AGENDA
PLANNING COMMISSION REGULAR MEETING
Wednesday, March 15, 2023, at 6:00 PM

1. Appointment of Chair and Vice-Chair
 - Legislative
 - Staff Presentation: Nicholas Wharton, Town Manager
2. Resolution PC-2023-02R: Ziggi's Site Plan
 - Legislative
 - Staff Presentation: Abdul Barzak, Town Planner

Date: 9.12.22 Resubmitted: 12.16.22, 2.7.23
 Project Name/Contact: Ziggi's Severance/Paul Bass (TST)
 Project Address: 9843 E. Harmony Road
 Customer/Project Number: 284 - American Eagle Properties attn. Jerry Helgeson
 Review Number: 3rd Submittal
 Project Coordinator: Abdul Barzak, Town Planner
 Recipients:

SITE PLAN

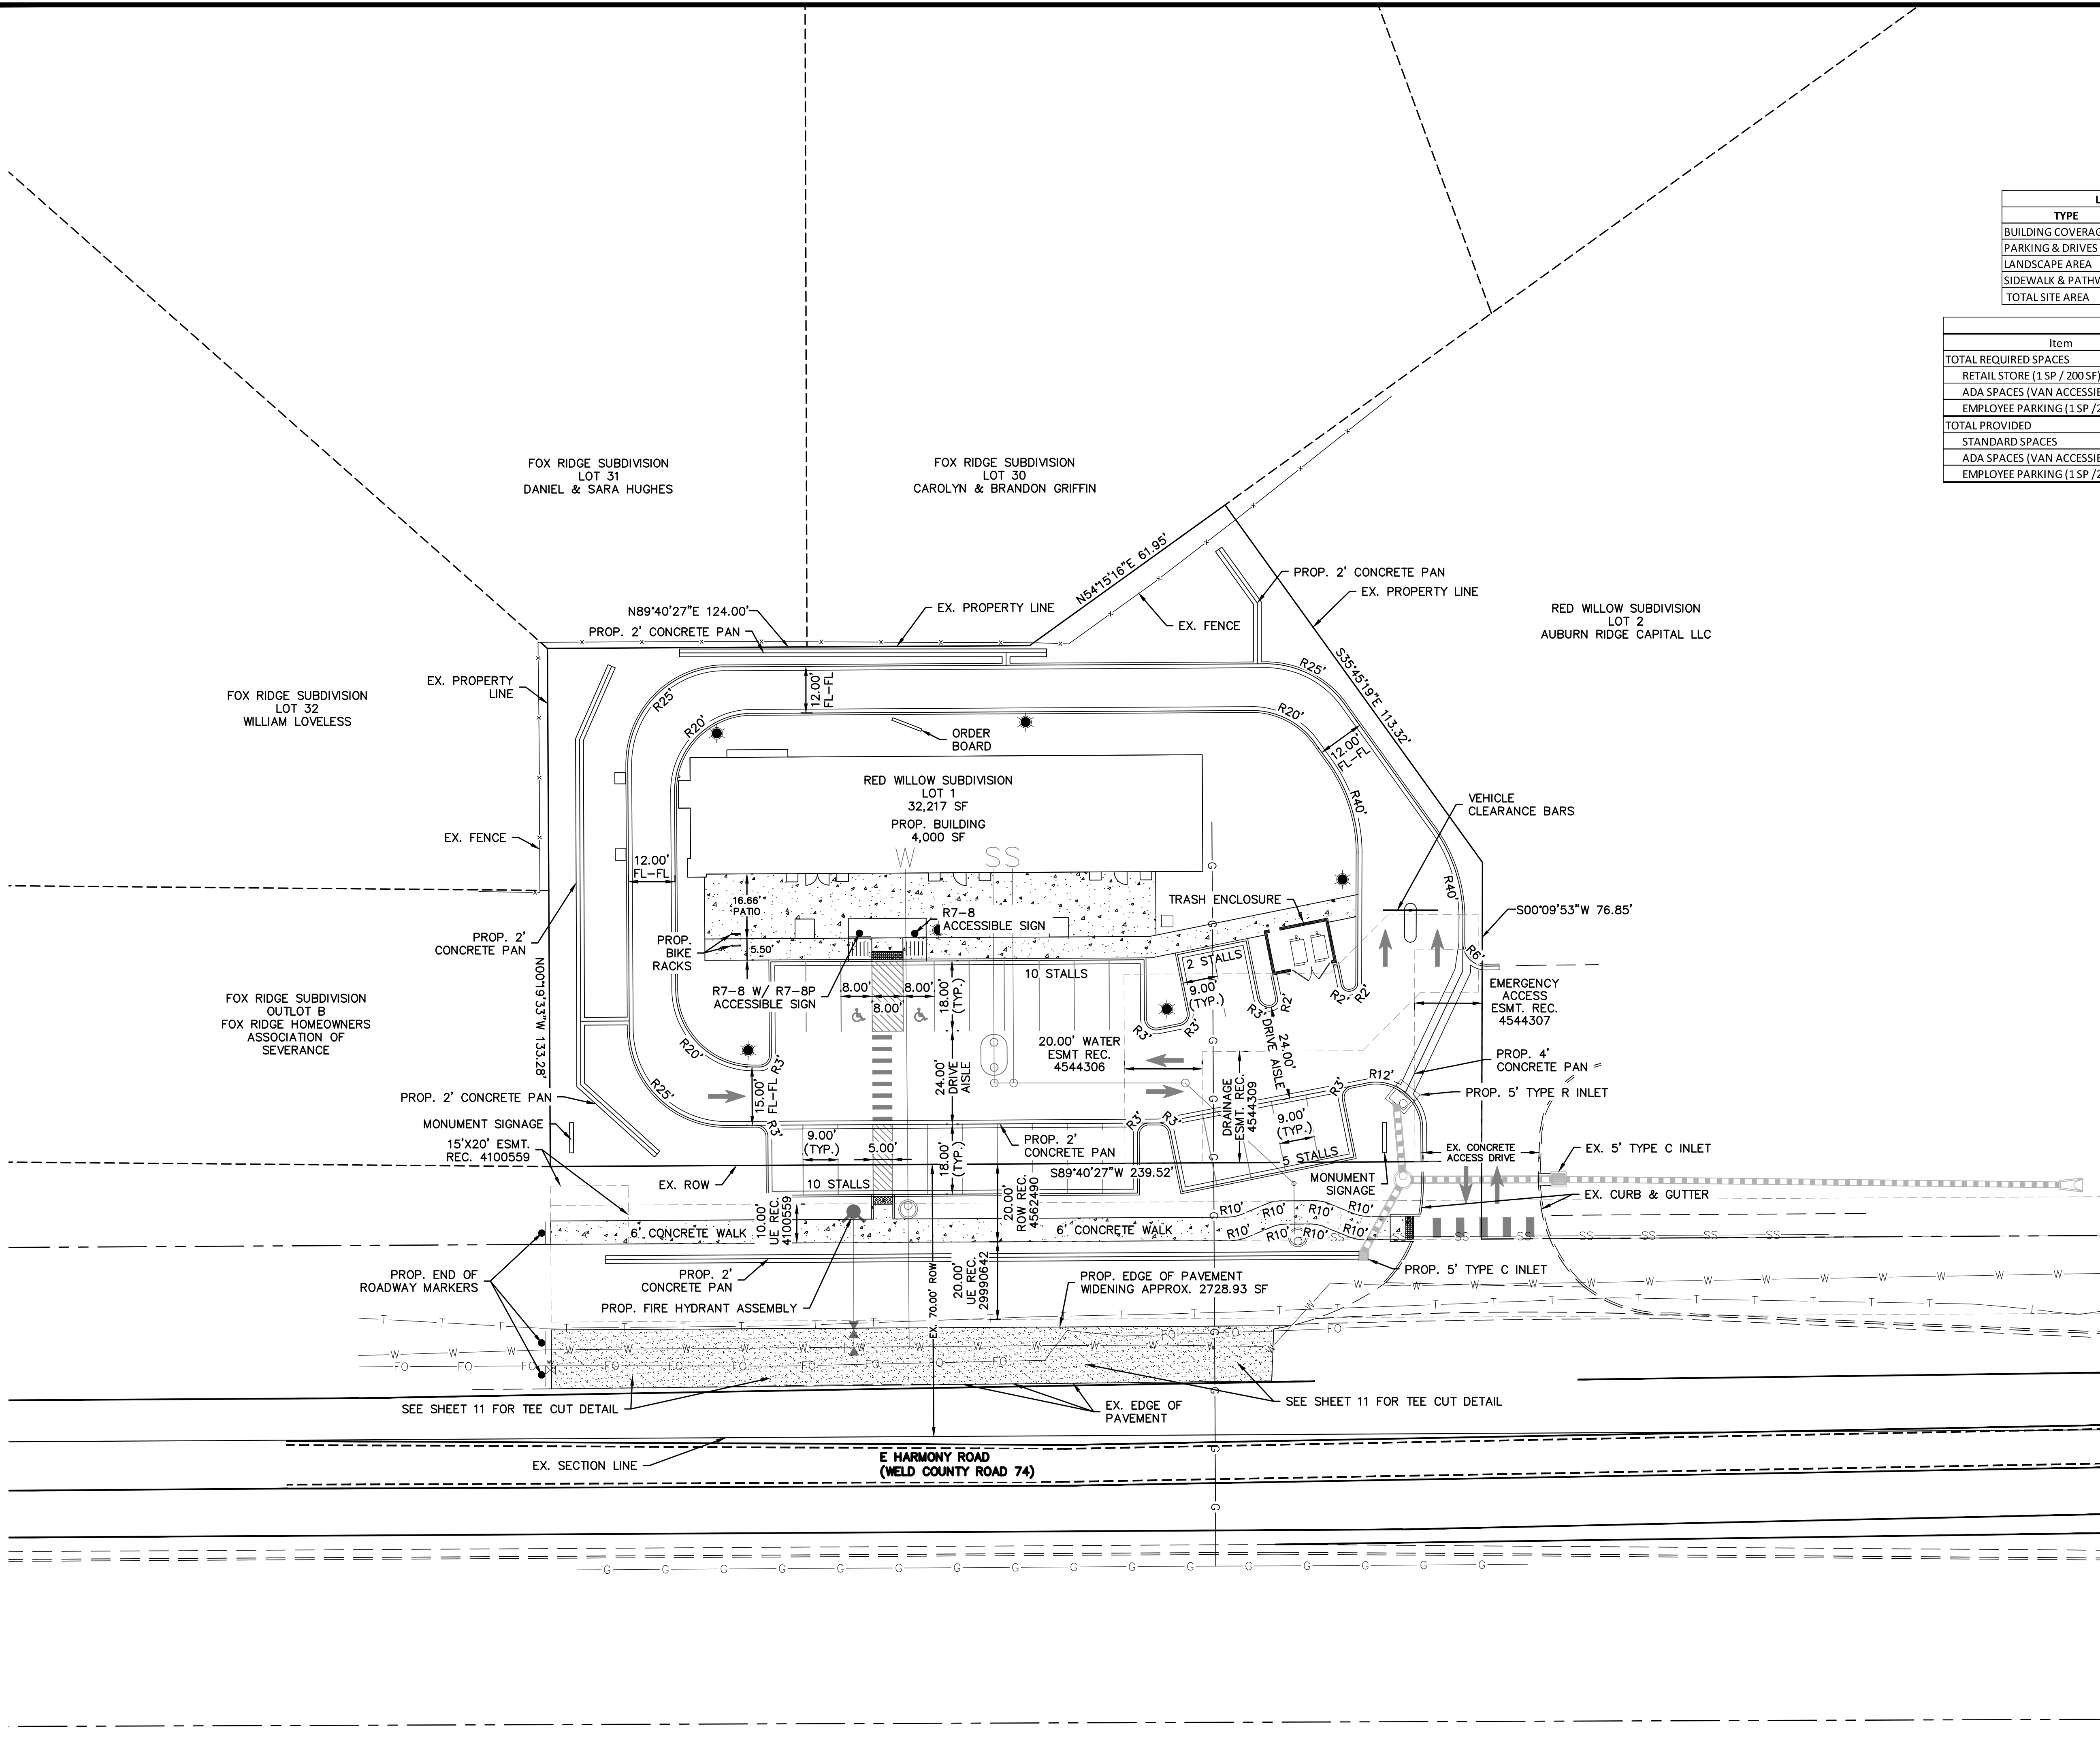
16. Sheet 4 (Site Plan, Encroachment) – A portion of the private improvements (parking lot) encroaches in the public road ROW of E Harmony Rd (WCR 74). The encroachment does not impede the widening of E Harmony Rd (WCR 74) to the ultimate section of 4 lanes of through traffic. As shown, when E Harmony Rd (WCR 74) is widened to the ultimate section the standard 24’ landscape strip would be reduced to 10’ along this property and the 6’ sidewalk would be located approximately 14’ inside the ultimate ROW instead of along the ROW. Engineering does not have an issue with the encroachment.

17. Sheet 4 (Site Plan, Site Access) – The site access is an existing private access created for the adjacent lot which contains the Dollar General Store. Refer to Town Attorney Comments. Site access modifications and construction need to be coordinated with Dollar General.
